Architectural Review Board

Meeting Minutes

ARB-27-2017 Certificate of Appropriateness

121 MILLER AVENUE CERTIFICATE OF APPROPRIATENESS & WAIVERS

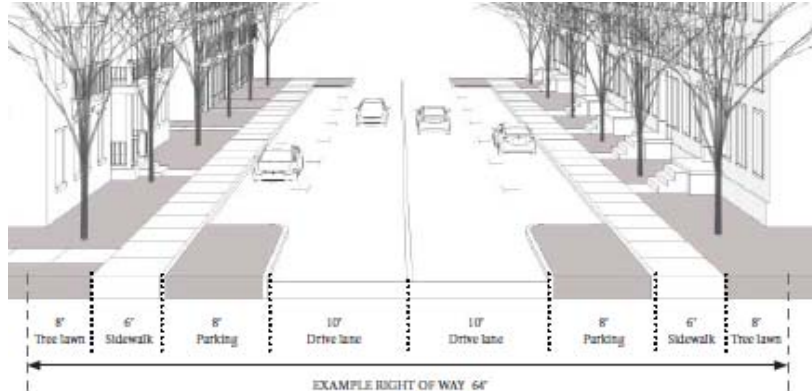
- The DGRs and Urban Center Code require the building height to be between a minimum of two and a maximum of three stories. The number of stories is measured above grade at the primary entrance to the building. Buildings should be appropriate in design, context, scale and massing. The commercial structures in the immediate area vary between 2, 2.5 and 3 stories in height for the entire building massing. The city architect has reviewed the proposal and recommends dormers are added to the wings to provide more appropriate massing and scale for the area. Staff recommends this is a condition of approval. See below:

1. Dormers are added to the building's wings per the city architect's comments.
2. The building's cornice detailing is subject to the review and approval of the city architect.
